ITEM NUMBER	6.4
SUBJECT	Planning Proposal for Land at 55-59 Kirby Street, Rydalmere
REFERENCE	RZ/26/2016 - D06629555
REPORT OF	Senior Project Officer
LANDOWNER	Fife Capital
APPLICANT	Mecone NSW Pty Ltd

The purpose of this report is to seek the Local Planning Panel's (LPP) endorsement to proceed with the Planning Proposal for land at 55-59 Kirby Street, Rydalmere in accordance with the Council Officer recommendations and recommend that Council forward it to the Department of Planning and Environment for Gateway Determination.

Figure 7. Site outlined in red showing the applicant's proposed 1.5:1 FSR

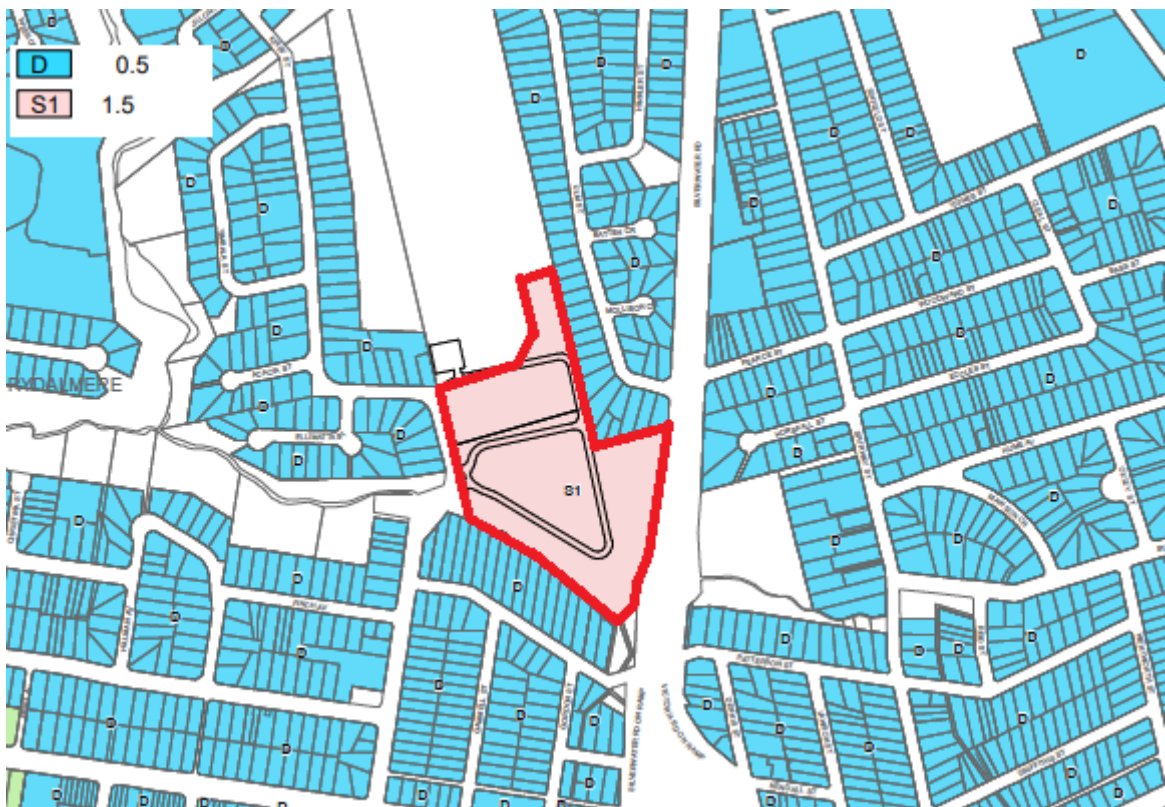
43. The applicant is proposing to increase the permissible floor space ratio (FSR) on the site from 1:1 to 1.5:1 and maximum building height of 31m. Council officers have raised significant concerns relating to this increase and do not support this change. The site is located within a low density residential area and such an increase will result in built forms that are not considered to be sympathetic to the existing character of the area. Council officers acknowledge that the site is suitable for some increase in density and an FSR of 1.3:1 and maximum building height of 20m is considered a more appropriate response by Council officers from an urban design perspective.

Figure 9. The Applicant’s proposed scheme

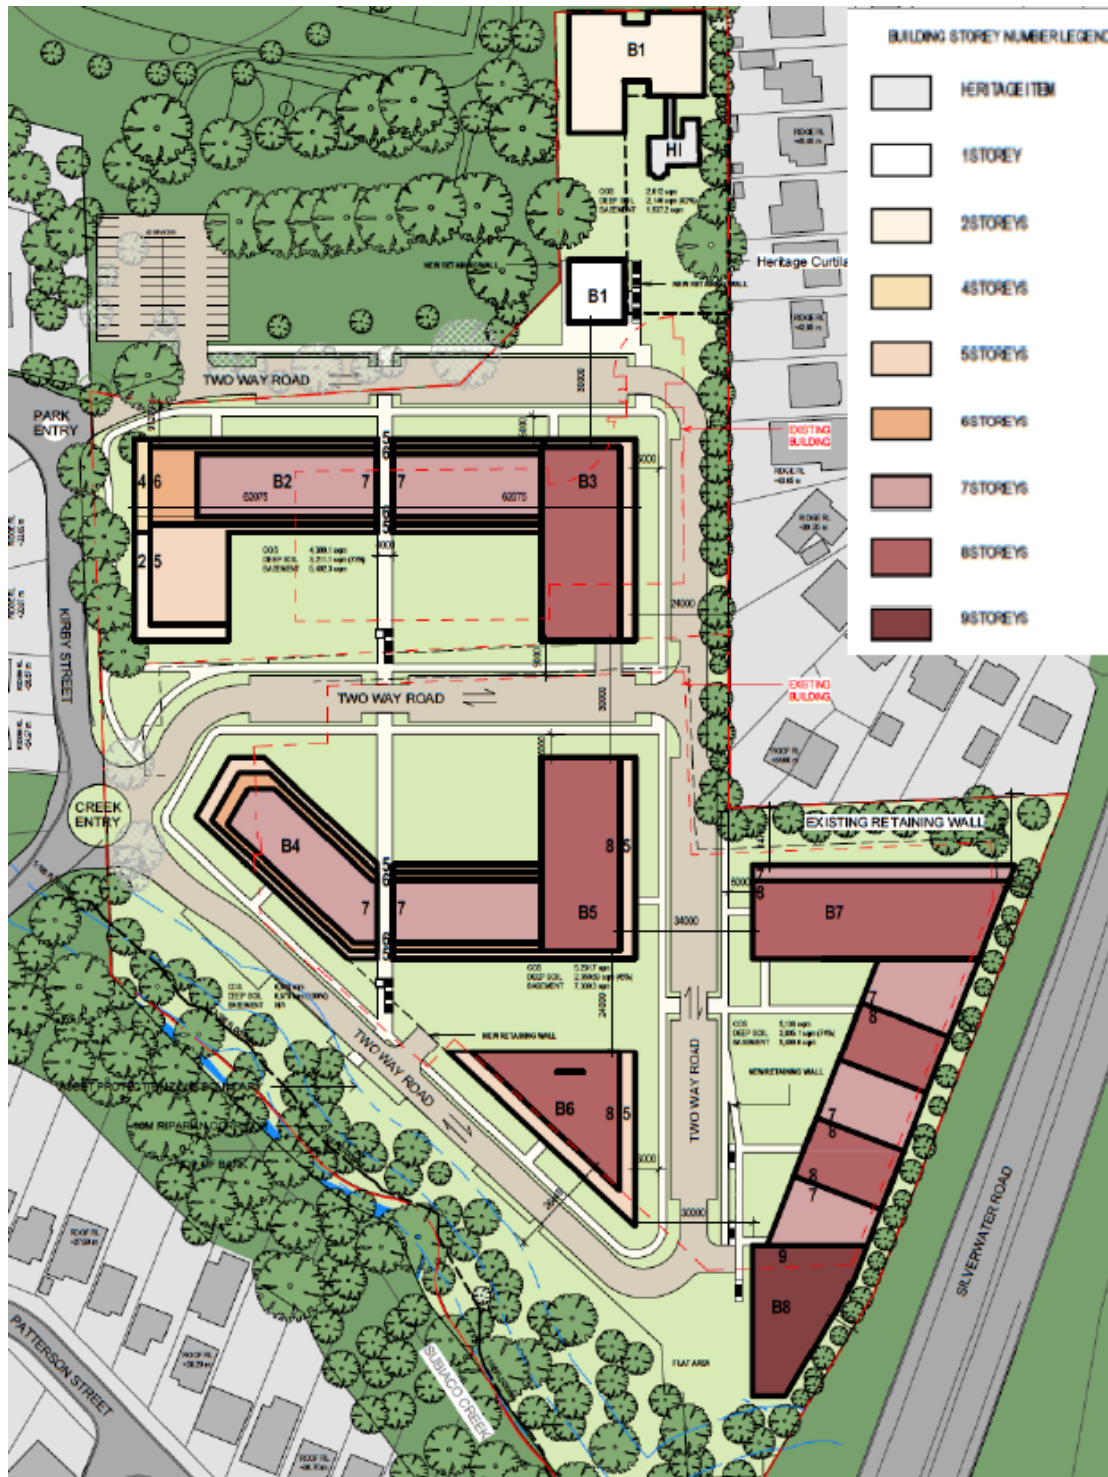
44. In addition, there is also a discrepancy between the number of storeys that can be achieved within 31m for high density residential development. The applicant is proposing a maximum of 8 storeys on the site, however it is possible to achieve a 10 storey development within 31m using Council's approach to converting a numerical building height to storeys. Feedback on the suitable FSR and building height has been provided to the Applicant on multiple occasions through the process, however the response has stated that redeveloping the site at an FSR of 1.3:1 is not feasible. Further detail on the feasibility matters is contained later in this report. Refer to **Figure 9** below showing the applicant's proposed scheme.

45. The site is relatively isolated and apart from the bus service on Victoria Road and small retail centre at Ermington, is not within close proximity to any major transport nodes or existing town centres that would typically be associated with development of the proposed density.

Figure 11. Council officers' preferred scheme

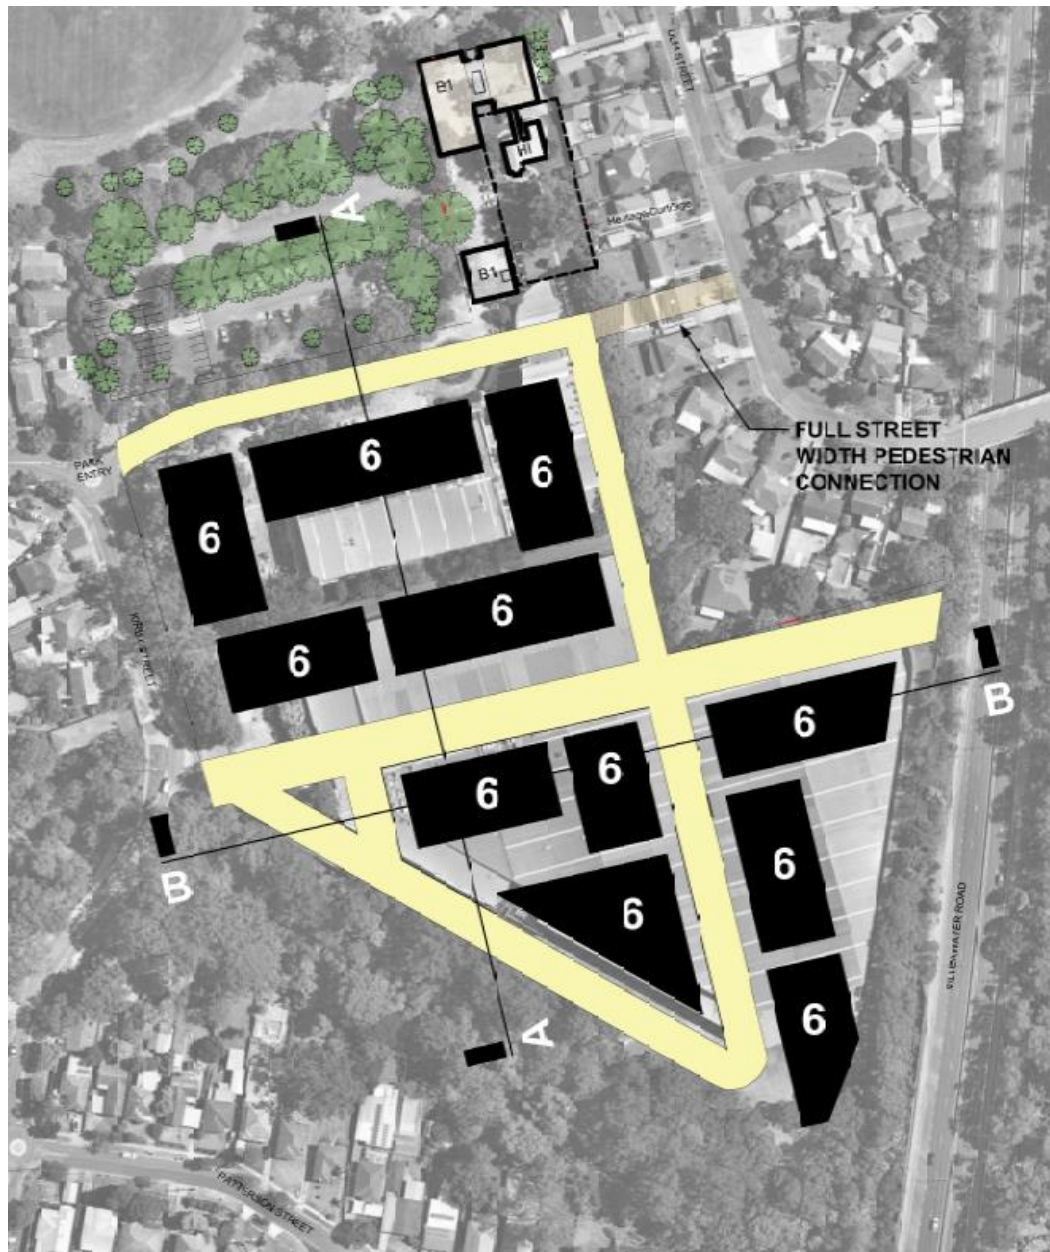
48. As a result, it is recommended a design with a block-layout that providing more centralised courtyards and a street-aligned building form with increased setback and a courtyard towards Silverwater Road is used instead. Refer to **Figure11** below for an indicative and preferred scheme that is considered to result in a better built form outcome for the site as it addresses the urban issues raised by Council officers. Note that a maximum building height of 6 storeys has been applied for visual purposes only and does not imply that this height is appropriate across the entire site.

Figure 12. Site sections comparing the two schemes

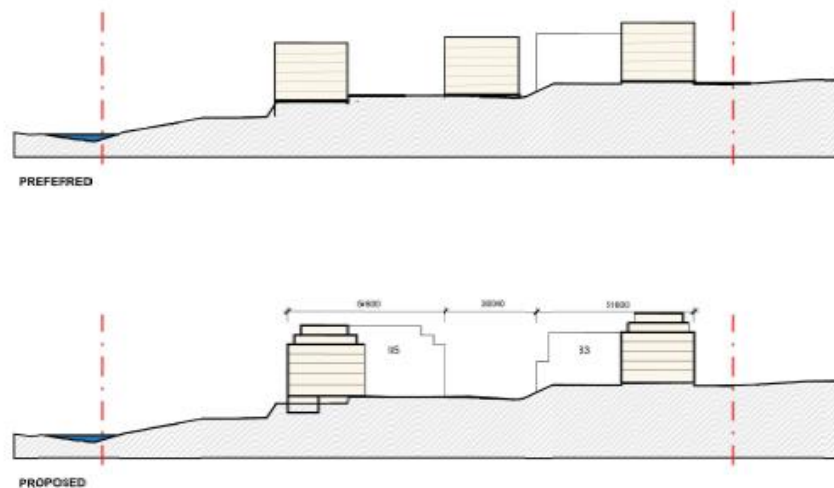
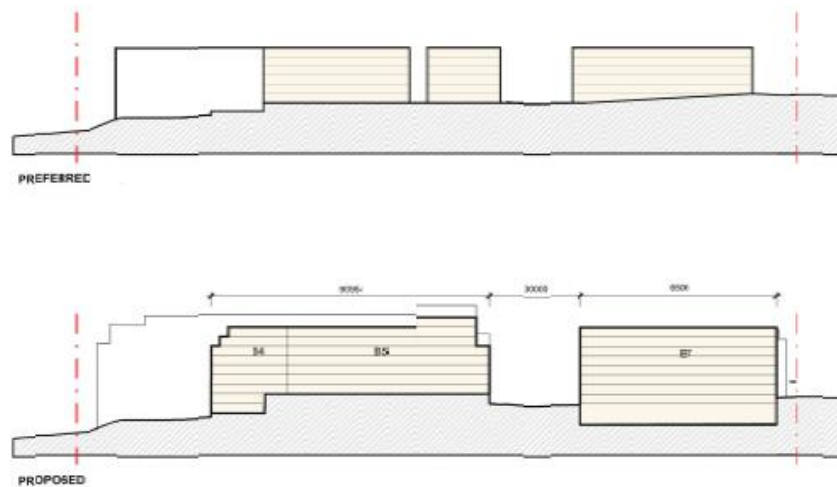
49. The two site sections contained in **Figure 12**, compare Council officers' indicative preferred scheme to the applicant's scheme from a north-south direction (Section A) and east-west direction (Section B). These sections highlight that the applicant's scheme produces a bulkier built form than that of the preferred scheme. The preferred scheme consists of a layout with smaller buildings on each block, which allows greater permeability across the site, improves the provision of communal open space by providing central courtyards and gives the impression of a less dense built form environment. It is considered this scheme produces a more appropriate response to the site and surrounding low density residential context compared to the applicant's.

Figure 14. Location of new roundabout providing access to the southern part of the site

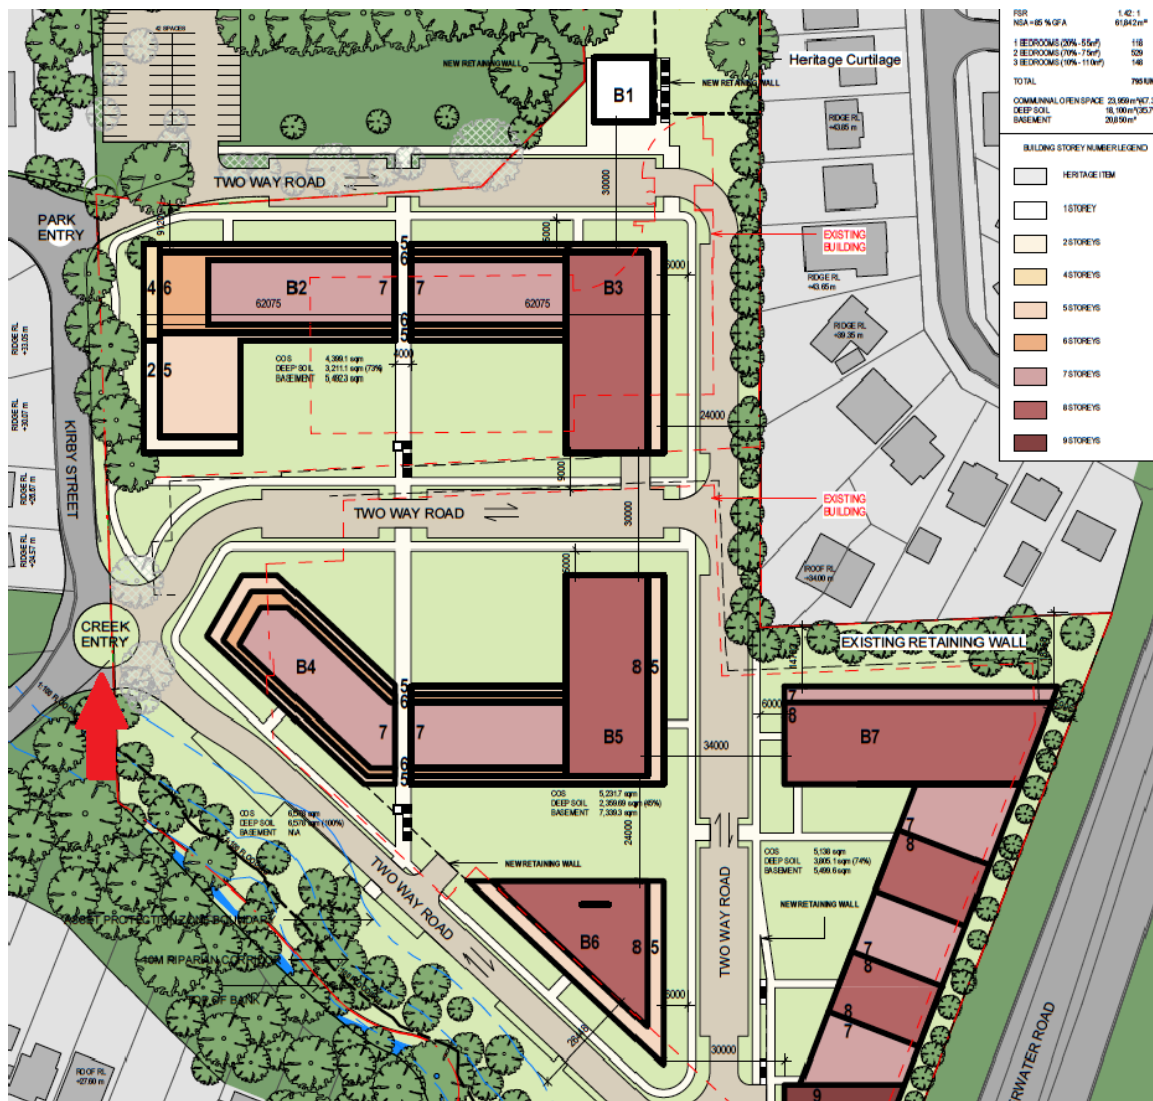
- 58. Existing site access is provided via a roundabout to 57-59 Kirby Street and is considered satisfactory. However, existing access to 55 Kirby Street at the southern end of the site is not considered suitable for any intensification of use due to its configuration (raised and semi-raised medians installed to reduce speed and corner cutting). As a result of Council officers' feedback, the applicant has amended the Proposal, identifying a new roundabout at this location. Council officers support this measure, however will need approval from the Parramatta Traffic Committee prior to construction. Refer to **Figure 14** below for the location of the new roundabout identified by a red arrow.

Figure 15. Image showing the constrained (undevelopable) land on the site (source: the Applicant's Planning Proposal)

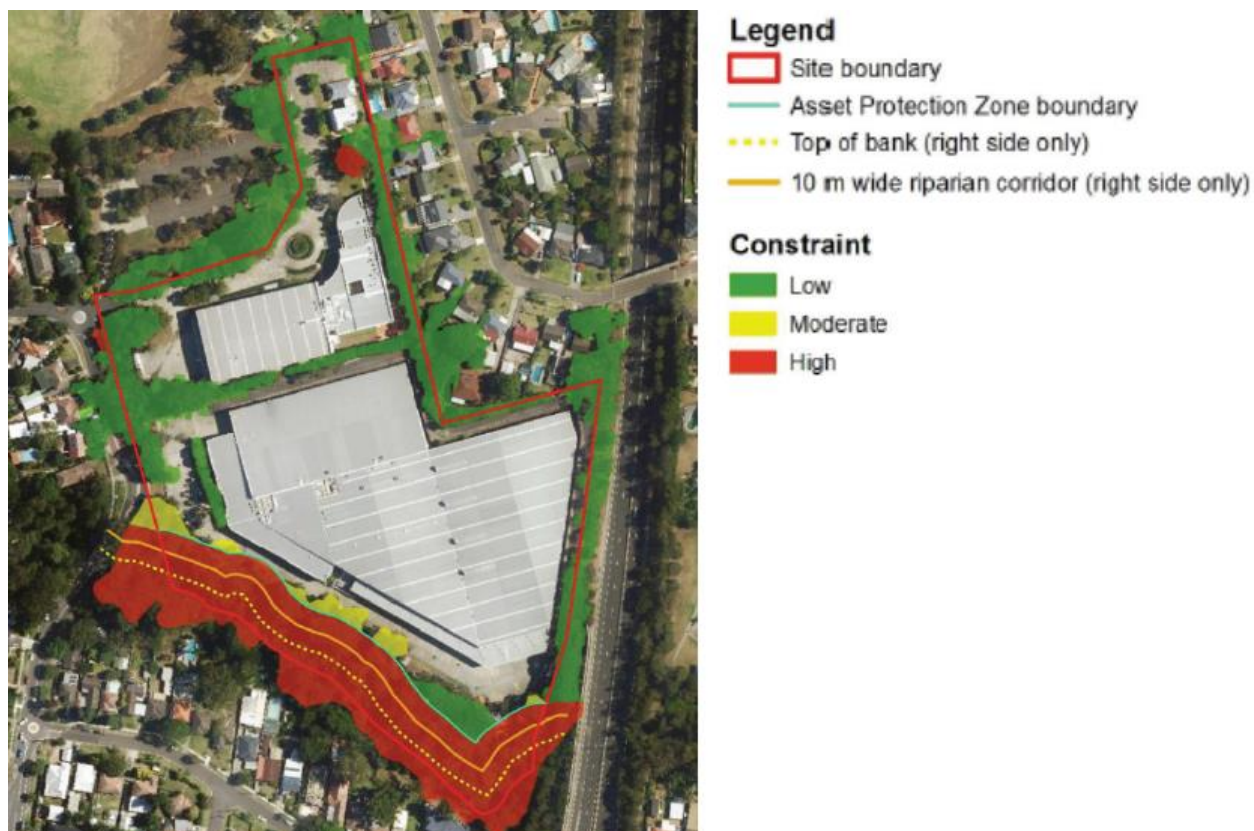
65. This land is significantly constrained and has no development potential. To ensure public access is secured in perpetuity consistent with the principle of the 'Green Grid', the Subiaco Creek riparian corridor should be dedicated to Council as a 'public reserve'. This will also facilitate consistent ongoing management of the corridor but is subject to any necessary remediation work being undertaken prior to transfer into Council ownership. Dedication of this land can be discussed in further detail as part of future VPA negotiations. Refer to **Figure 15** for a map showing the constrained land on the site.

Figure 16. Location and extent of private access road located on Council-owned land

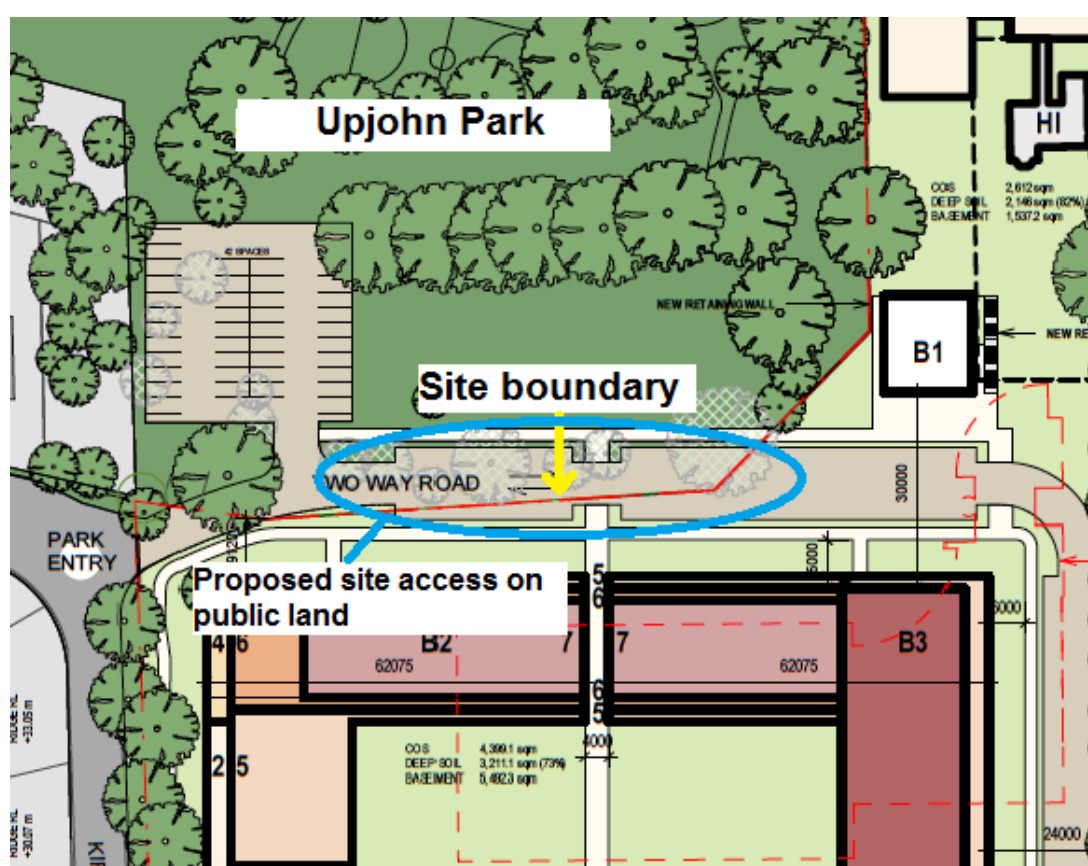
72. The current access arrangement to both Upjohn Park and the subject site is via two driveways coming off one roundabout. This arrangement is not considered satisfactory as it is not consistent with the current Australian Standard (AS2890.1). Under this standard, a minimum 6m separation distance is required between a driveway access and an intersection and the current arrangement provides only 4m. Retention of this current access arrangement is not supported as part of redevelopment of the subject site.

73. In order to resolve this issue, discussions between the applicant and Council officers took place where it was agreed that in order to rectify this issue, some public land could be used in order to improve site access to the park and car park as well as the subject site providing that upgrades to the existing car park and Upjohn Park were undertaken by the applicant. The current size of the Upjohn Park car park exceeds the needs of the park and the surplus space that was formerly used by the car park could be used to provide for better active recreation facilities, such as a hard court. As such, it is considered that some public benefit would be gained with this arrangement.

74. Although Council officers do not raise an issue with the use of some Council land for the road in principle to provide improved access to the park and car park, the extent of land proposed to be occupied requires some further refinement and it is recommended that this be undertaken by the Applicant to the satisfaction of Council as part of the DCP and VPA processes. Refer to **Figure 16** showing the location of the potential road circled in blue.
